ADDENDUM NUMBER 1

MARTIN LUTHER KING COMMUNITY CENTER
HVAC SYSTEM REPLACEMENT

Project Number: P202-13610
Notice Number: 6879

Date of Addendum: November 21, 2013

1 PARTIAL MECHANICAL ROOF NEW WORK PLAN
1/8" = 1'-0"

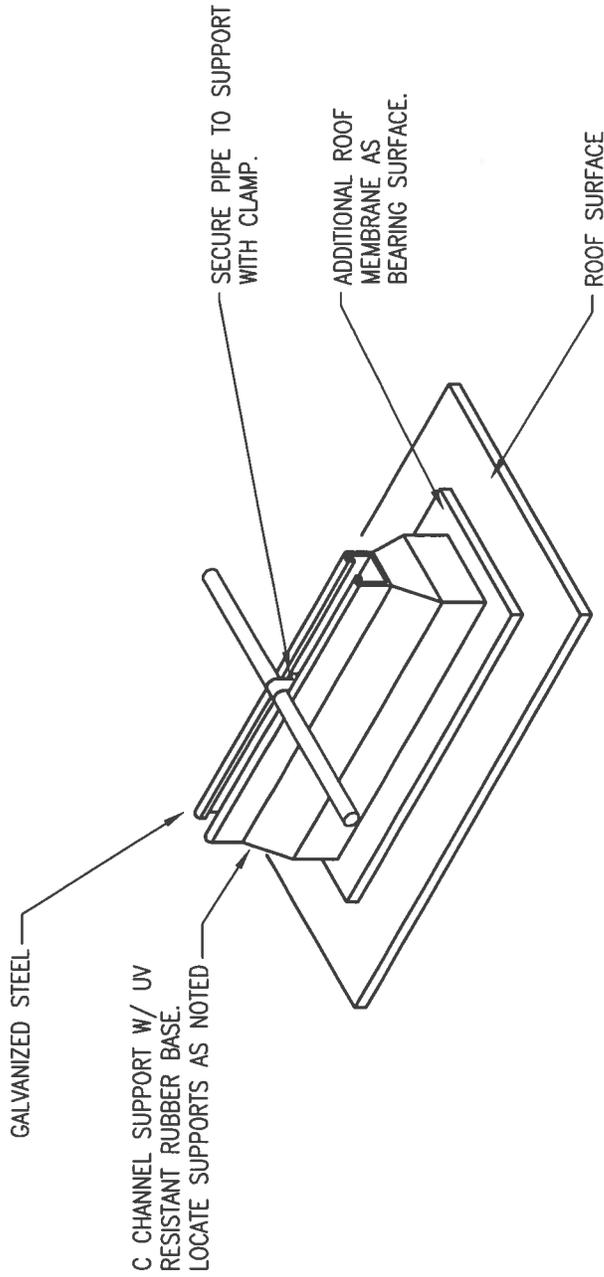
REVISE location of ACC-1 as shown on addendum sheet M-1.

REVISE location of fence around ACC-1 as shown on addendum sheet M-1.

REVISE fencing notes as shown on addendum sheet M-1.

REVISE location of roof hydrant as shown on addendum sheet M-1.

FENCE POST ROOF FLASHING DETAIL

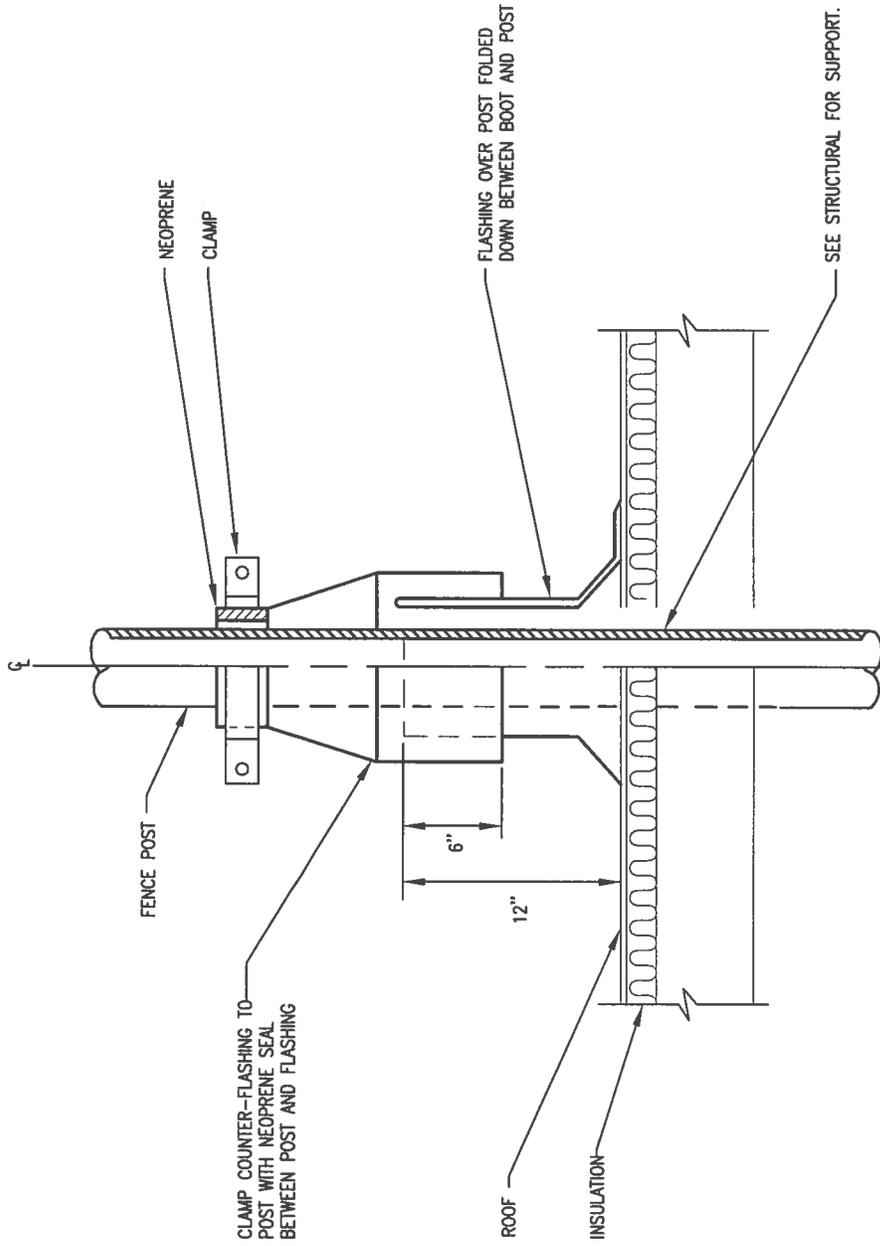
ADD Detail 14, Fence Post Roof Flashing Detail. See sheet M-3.

1 PARTIAL ROOF FRAMING PLAN

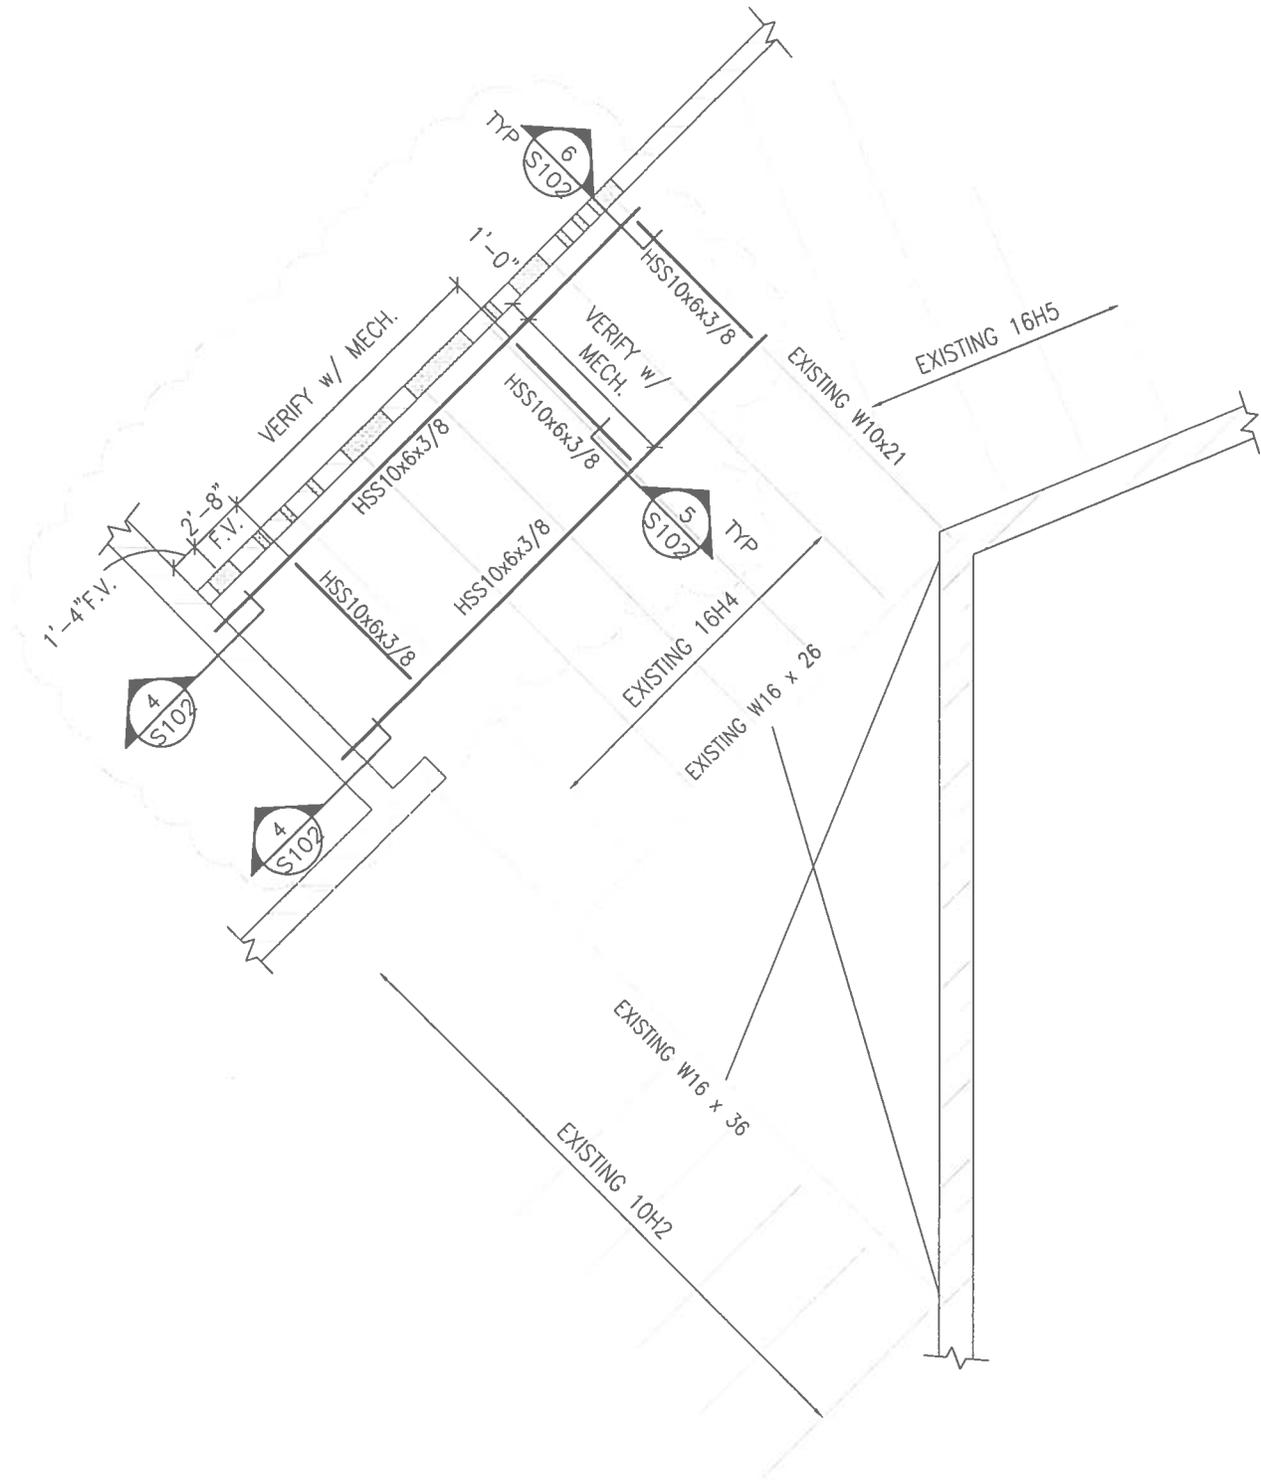
ADD section cuts to plan, see S-5.

REVISE location of roof top unit framing, see S-5.

REVISE beam sizes per S-5.

4 STEEL BEARING ON MASONRY

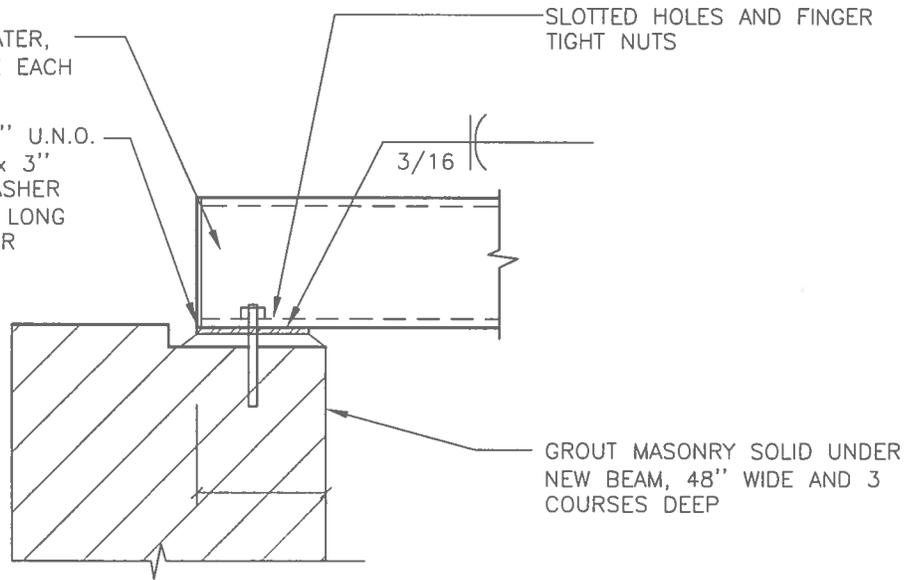
ADD details 4, see S-6.

5 TYPICAL FRAMING SECTION

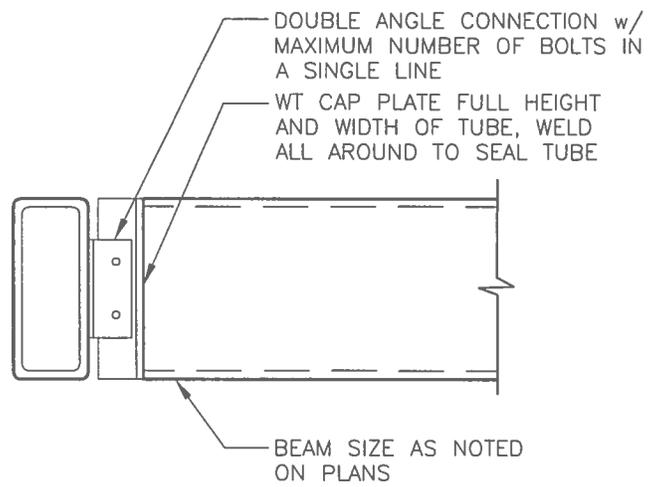
ADD detail 5, see S-7.

6 NEW UNIT SUPPORT BEARING DETAIL

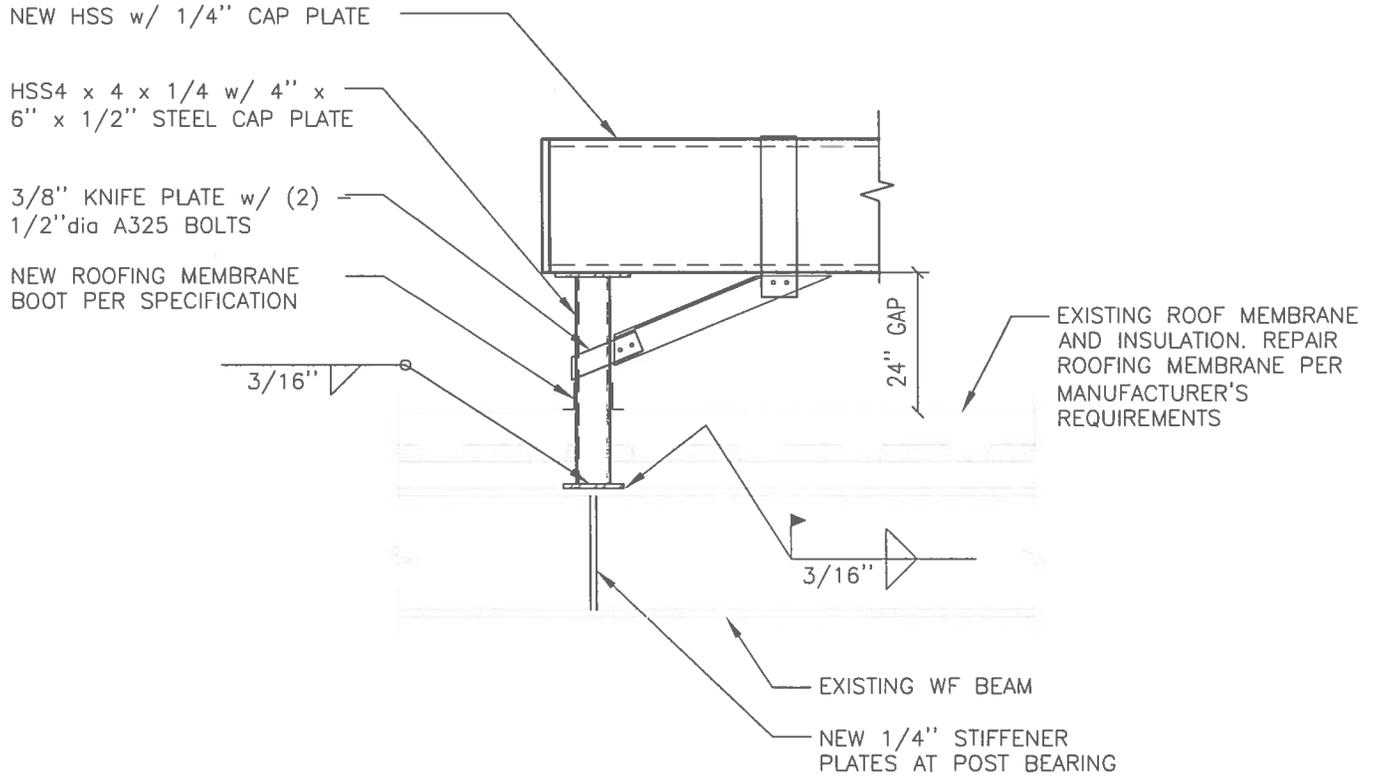
ADD detail 6, see S-8.

JOIST REINF. AT FENCE POST

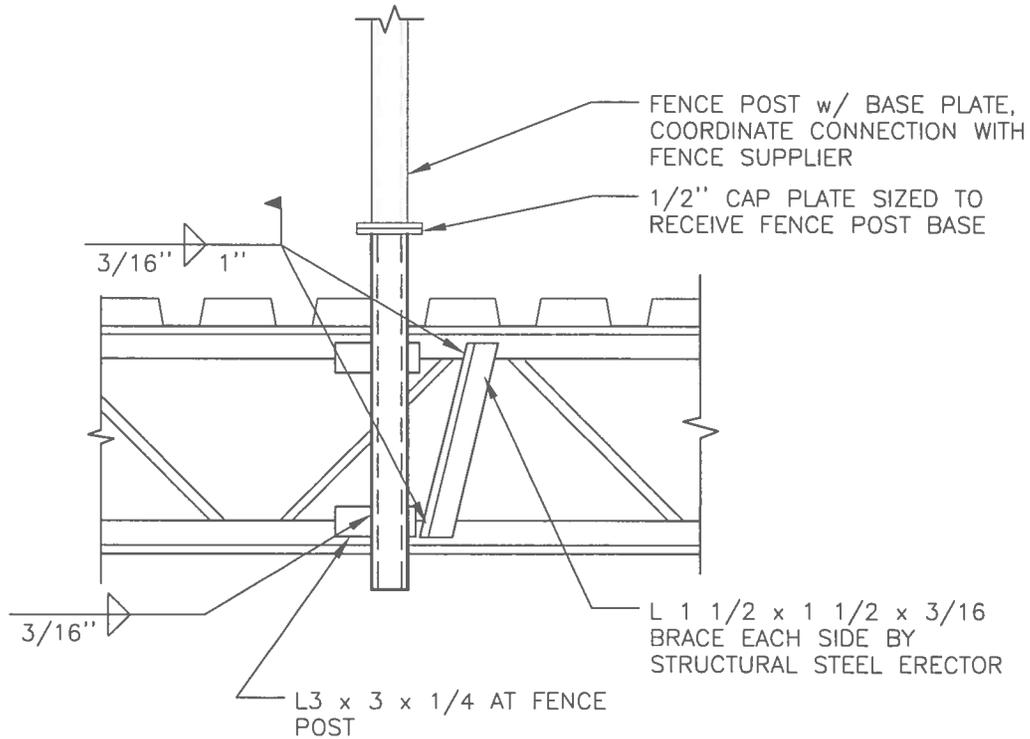
ADD detail 8, see S-9.
